Deucheran Hill 2 Wind Farm Scoping Opinion

**The Scottish Government
Energy Consents Unit**

**Scoping Opinion on behalf of Scottish Ministers under the
Electricity Works (Environmental Impact Assessment) (Scotland)
Regulations 2017**

**Deucheran Hill 2 Wind Farm
Koehler Renewable Energy UK Limited**

Figure 1: Proposed development location shown on an airways chart

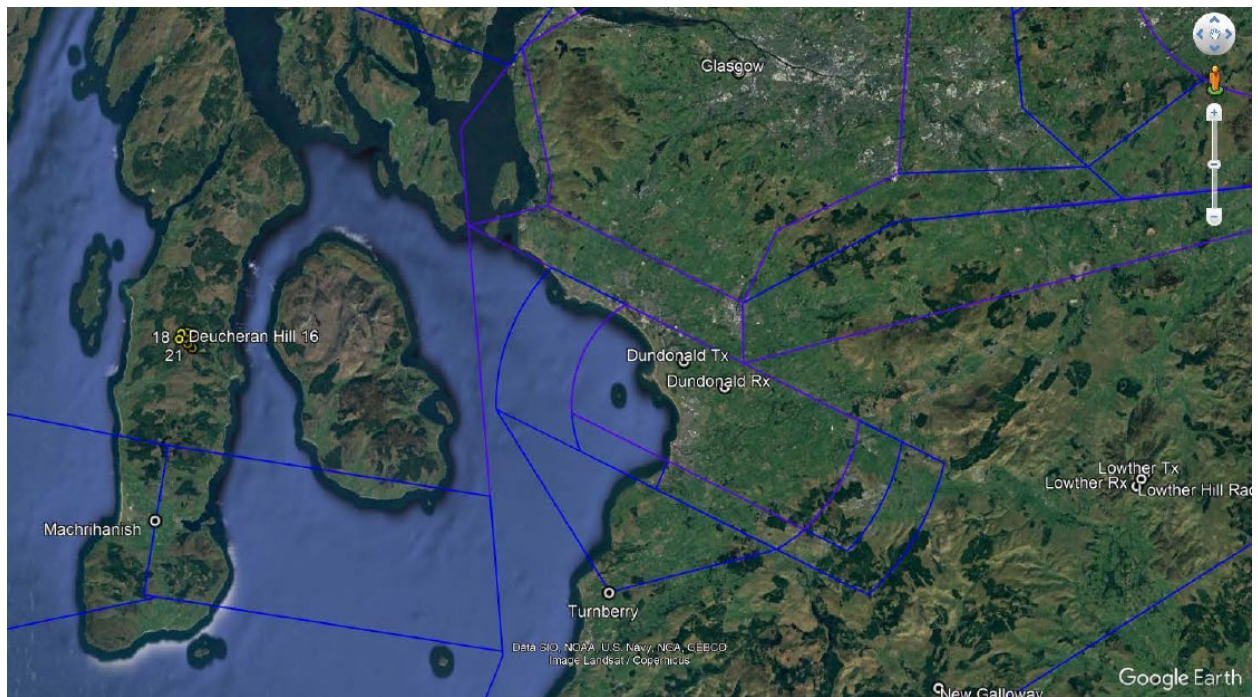
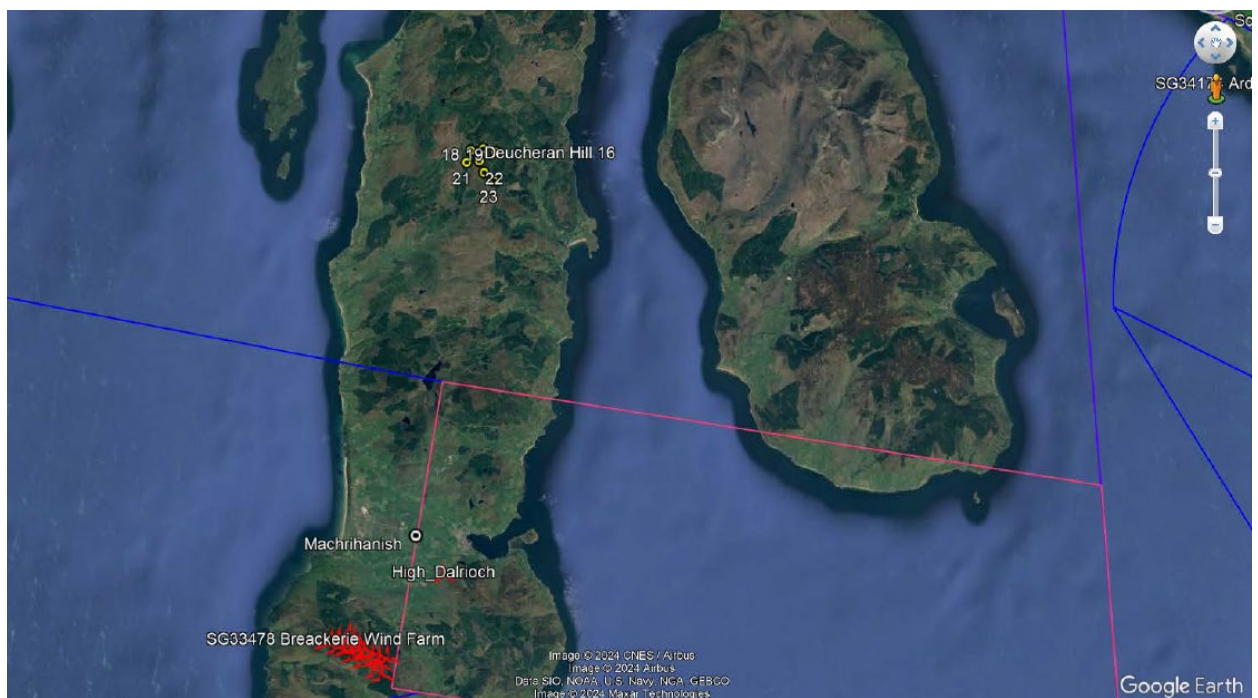
Unit or role	Comment
Prestwick Centre ATC	Unacceptable
Military ATC	Acceptable
